Planning and Zoning Commission

December 03, 2019

TO: Planning and Zoning Commission
FROM: Alex Pfaltzgraff, Development Services Director
DATE: December 3, 2019
RE: Legacy Park Lot 1 – Site Plan

RE: Legacy Park Lot 1 Site Plan

Exterior Elevations

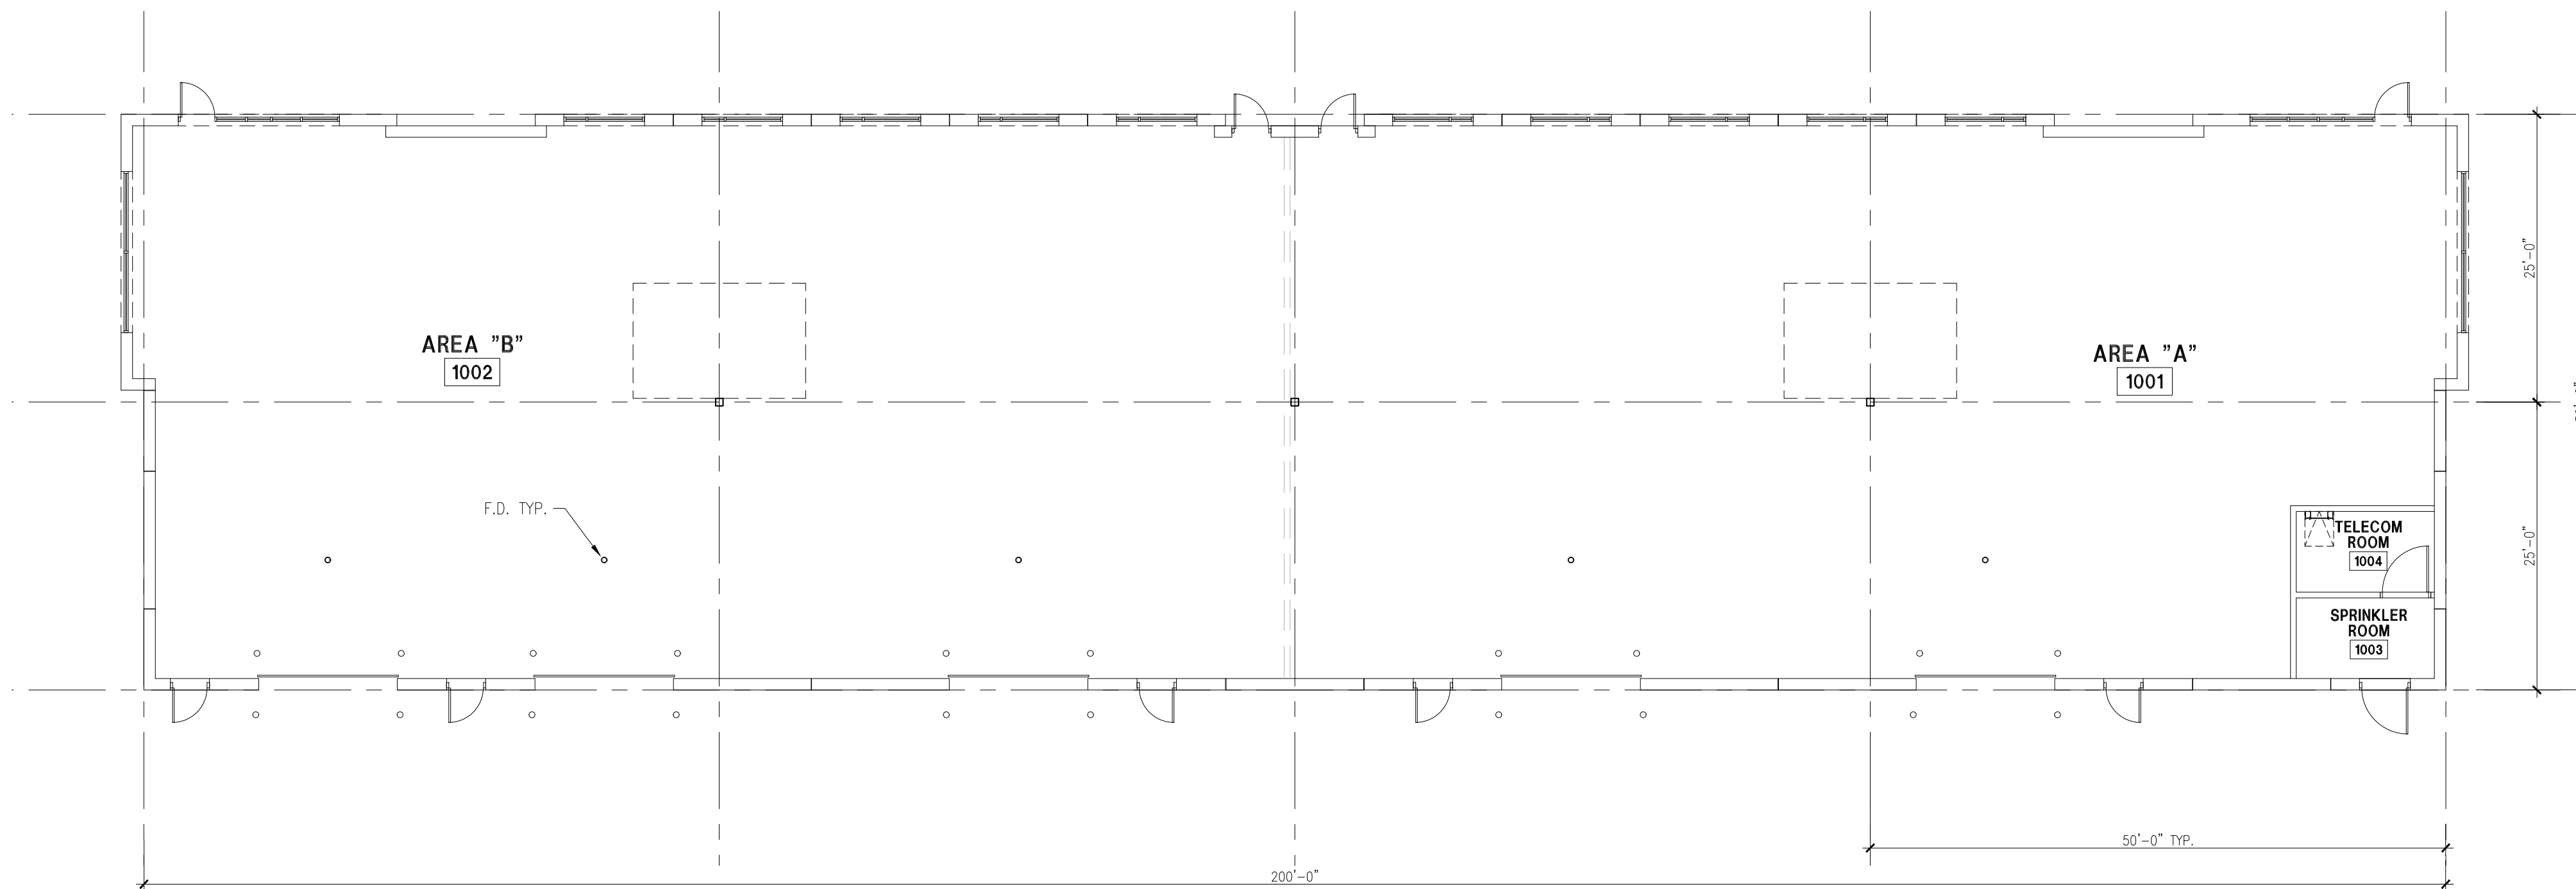
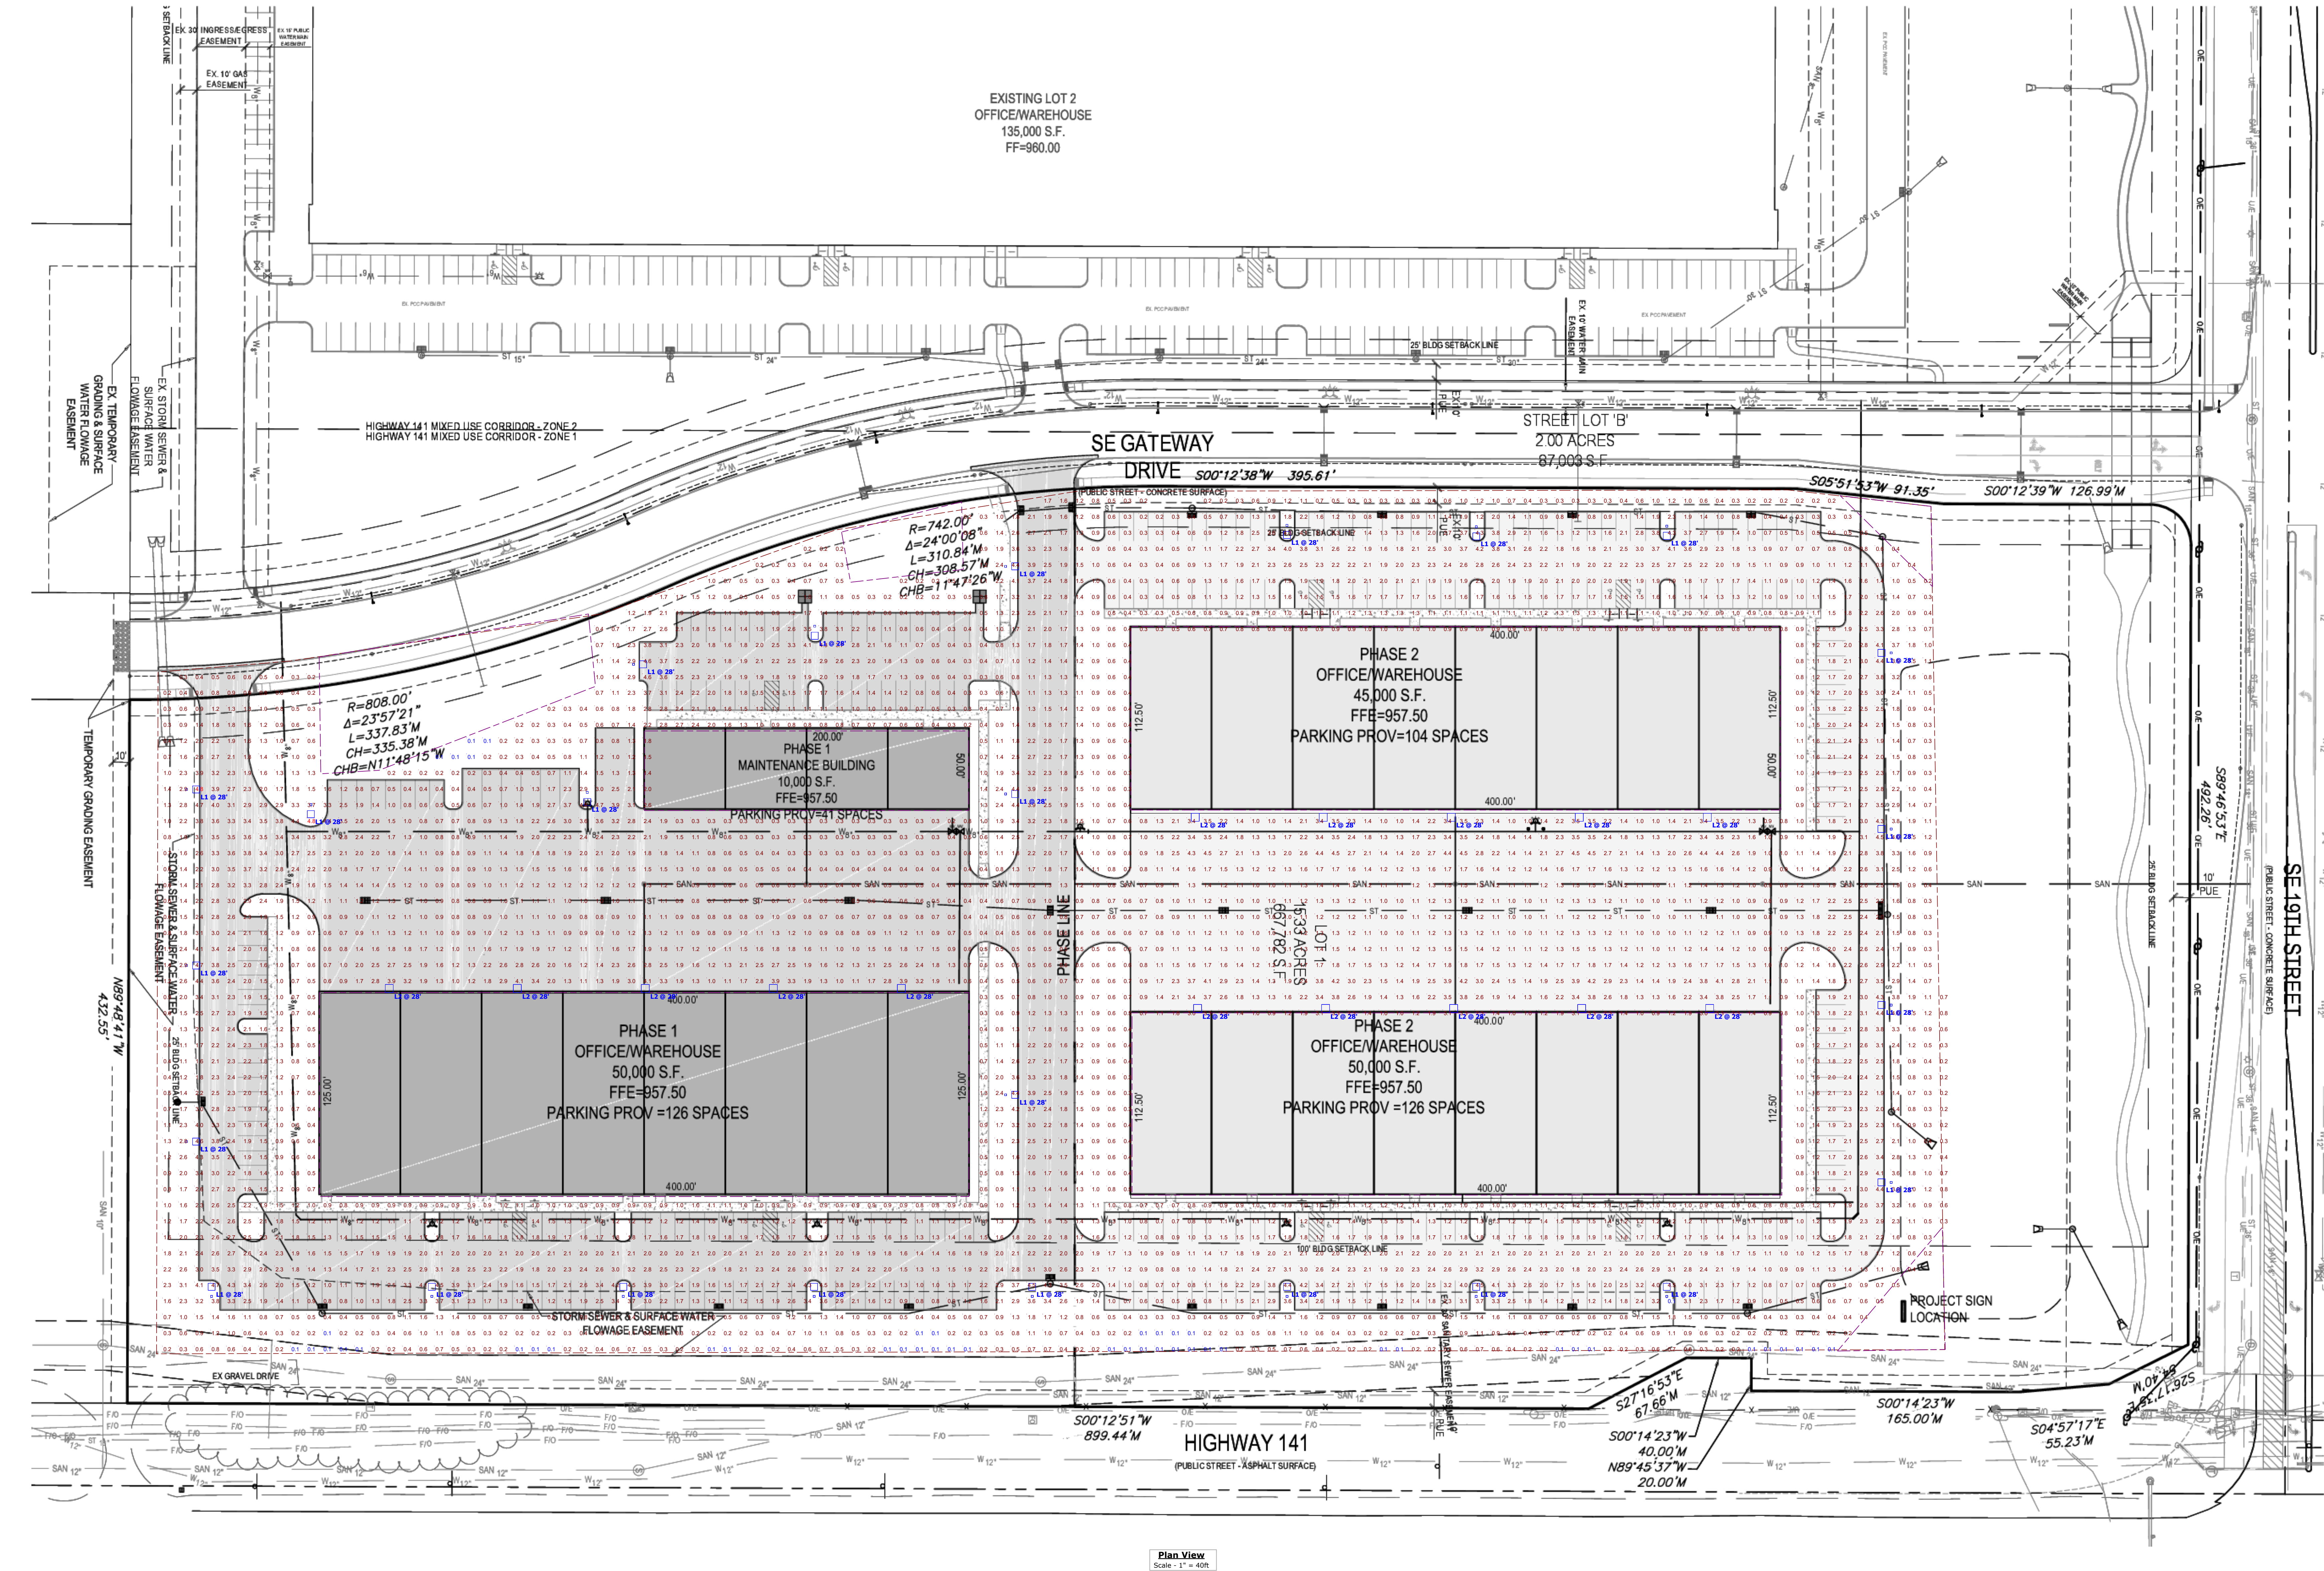
- ~~50. Please provide the required 5 architectural factors as required in 165A. Please note the 5 required factors on the architectural sheets.~~

~~51. Please revise the elevations to meet the minimum glazing requirements. Chapter 165A requires that 30% of the elevations facing the Public ROW to be glass. The architect has instead calculated the horizontal length. Based upon staff calculations, additional glazing is needed. If the area above each existing window is replaced with glazing, the minimums would likely be met.~~

~~52. Please provide the roof deck height as it relates to the parapet. Note that all roof top mechanical units must be screened from view if above the parapet height.~~
